# UC RIVERSIDE | THE BARN EXPANSION PROJECT

## 2016 ADDENDUM TO THE 2012 DETAILED PROJECT PROGRAM UPDATE

**FERNAU & HARTMAN ARCHITECTS**

**MARCH 24, 2016**

SITE PLAN - OPTION 1

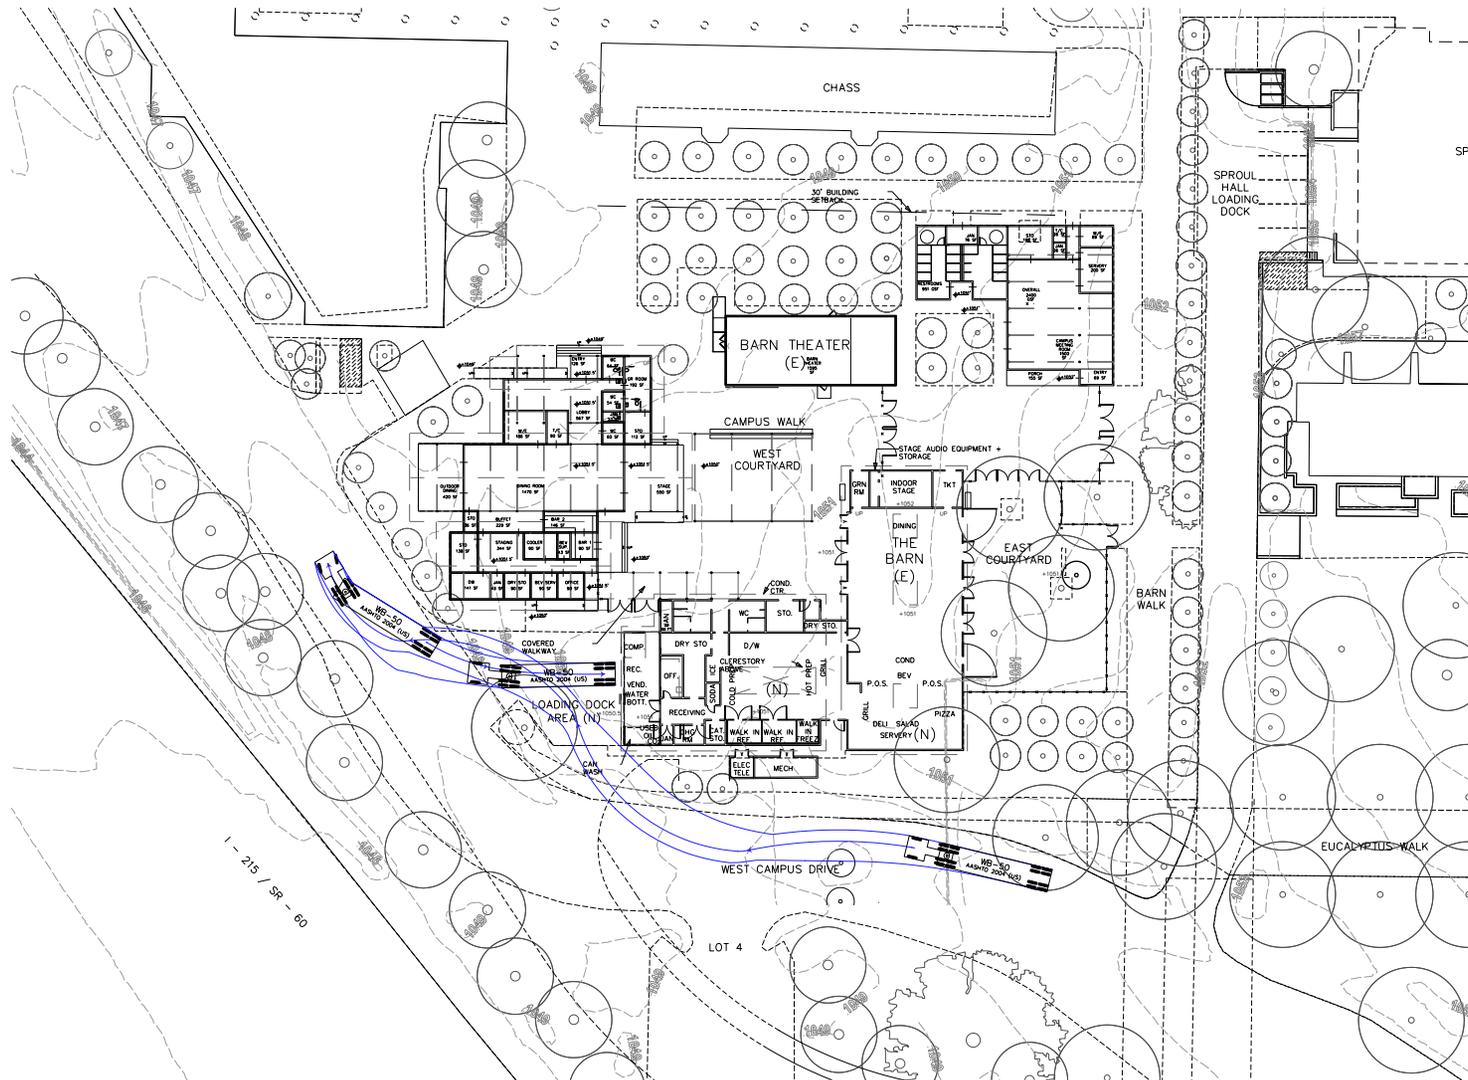
**Option 1** -- shows a re-oriented Faculty / Staff Dining Facility raised to the level of the Stage, and the Campus Meeting Room combined with the East Courtyard Restrooms in the northeast corner of the site. As in 2012, the Barn is expanded north, leaving more landscape and a large tree on the south. At the Loading Dock, a single curb-cut for entry and exit at the southwest corner is shown.

**CIRCULATION STUDY - WB-50 ROUTE 2**

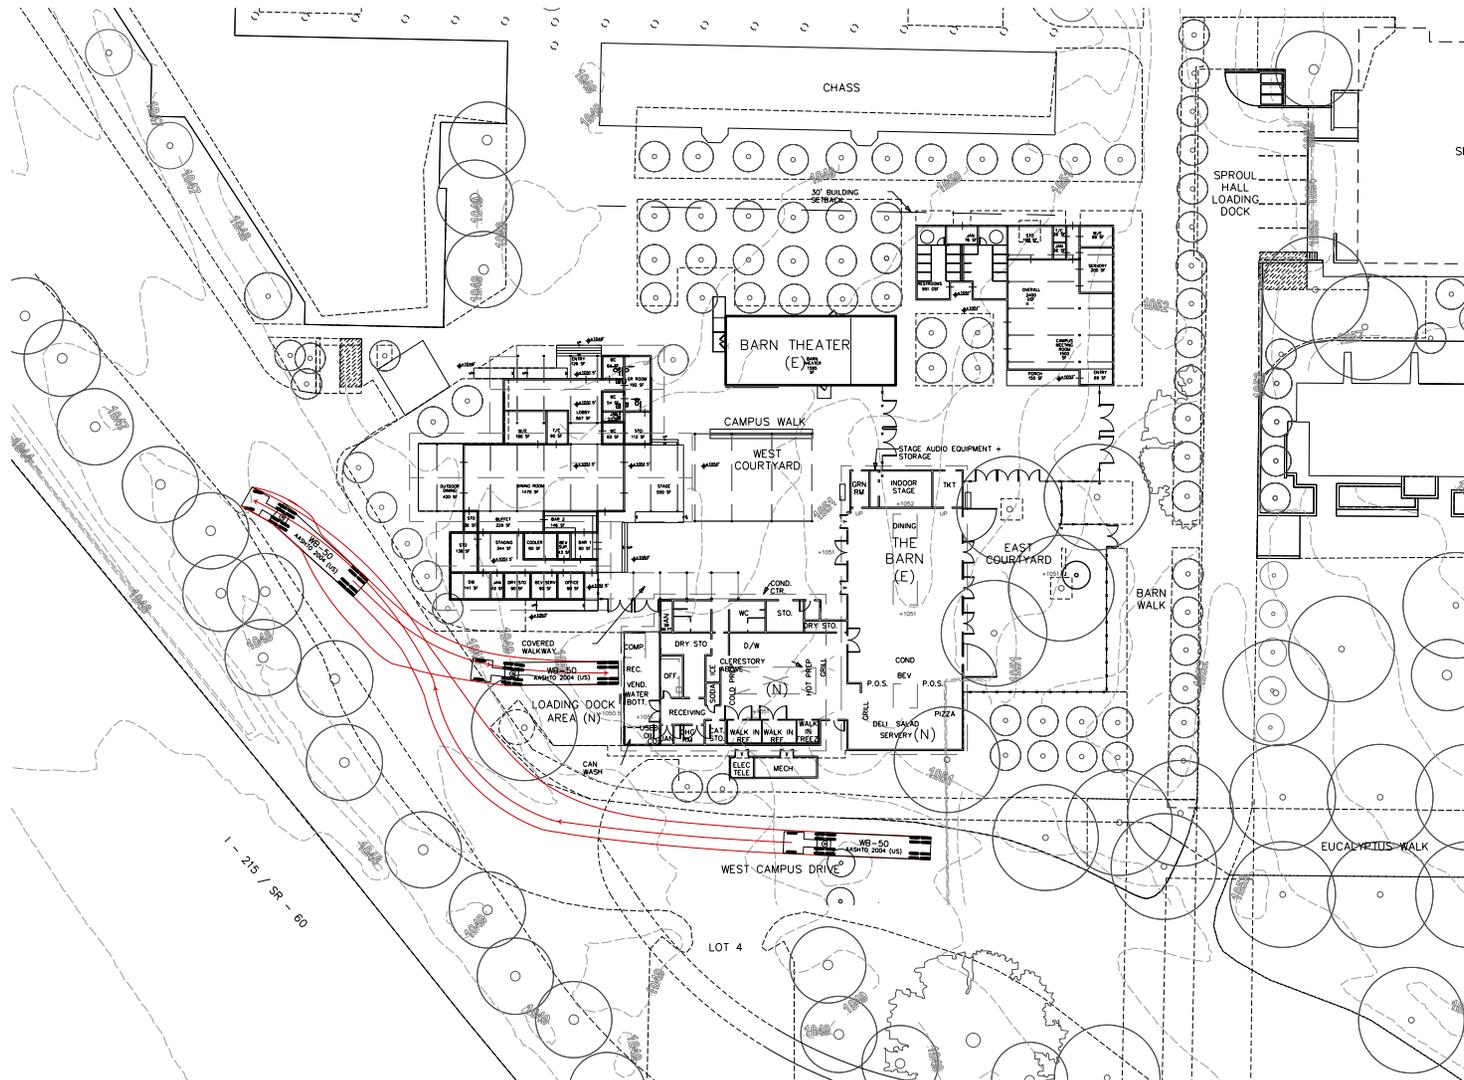
1. THIS STUDY SHOWS A SINGLE CURB CUT AT WEST CAMPUS DRIVE, WITH A SINGLE 50' TRACTOR TRAILER BACKING INTO THE LOADING DOCK. VIEWS OF THE LOADING DOCK ARE BUFFERED WITH PLANTINGS AND PEDESTRIANS CAN WALK ON A SIDEWALK.

# Loading Dock Area Studies - Composite Site Plan Option 1 w/ two (2) 50' Trucks Simultaneously

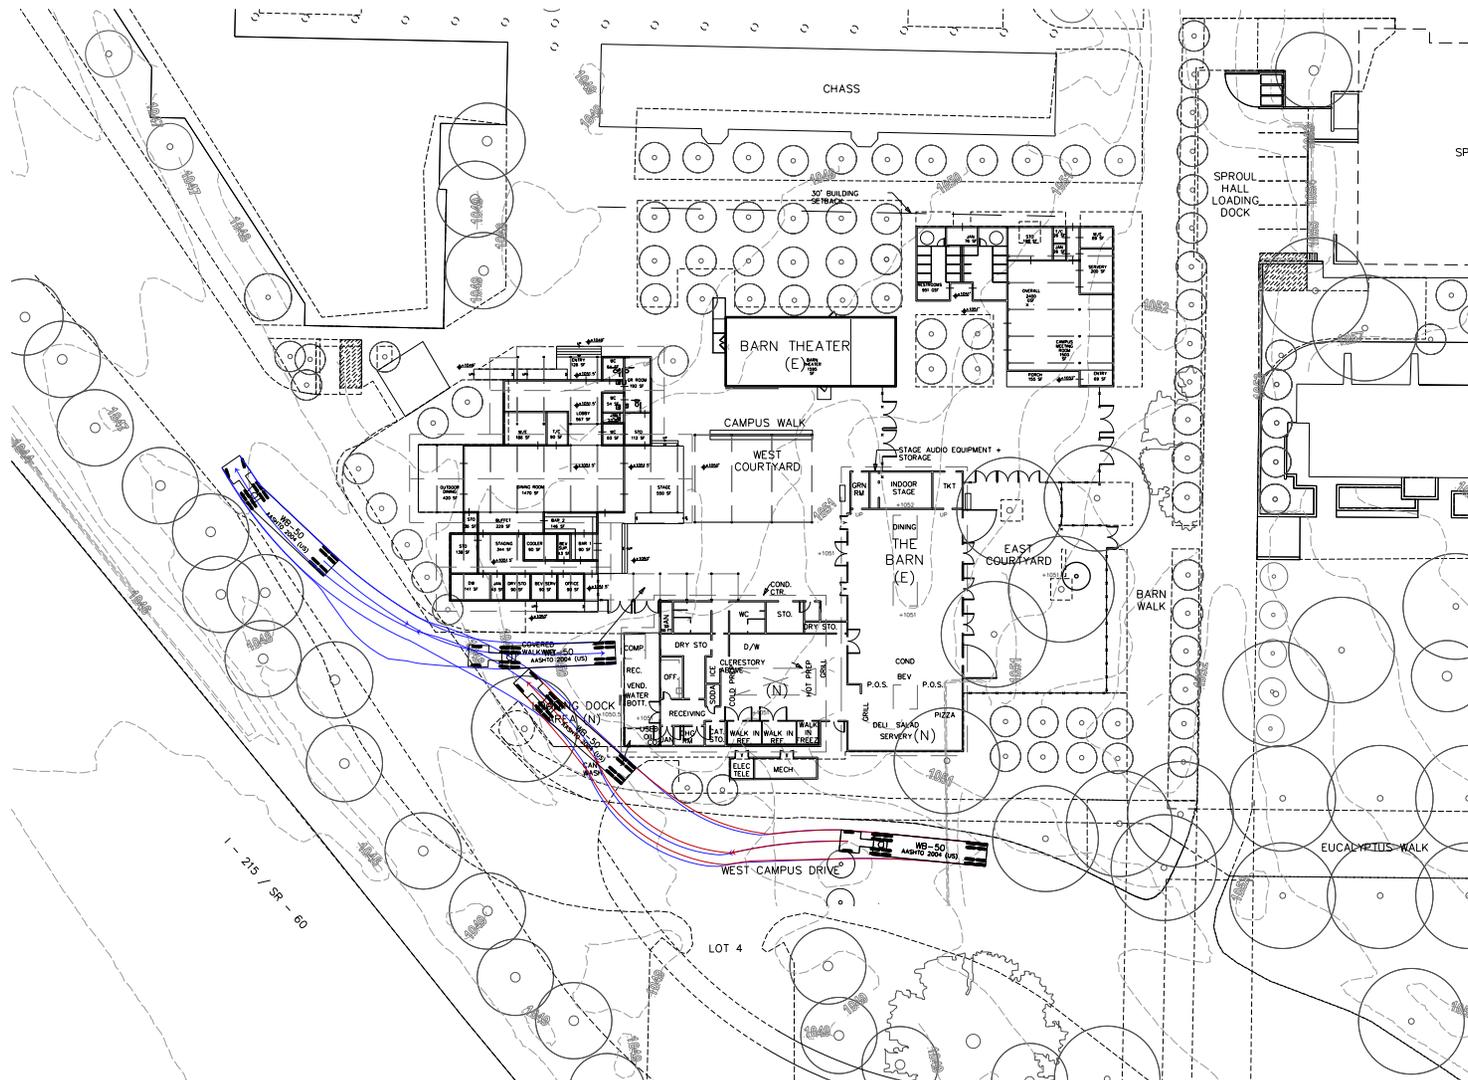
1. THIS STUDY SHOWS TWO CURB CUTS AT WEST CAMPUS DRIVE, WITH ONE TRUCK BACKING INTO THE LOADING DOCK AND A SECOND TRUCK PULLED OFF THE DRIVE FOR WAITING AND UNLOADING. VIEWS OF THE LOADING DOCK ARE BUFFERED WITH PLANTINGS AND PEDESTRIANS CAN WALK ON A SIDEWALK.
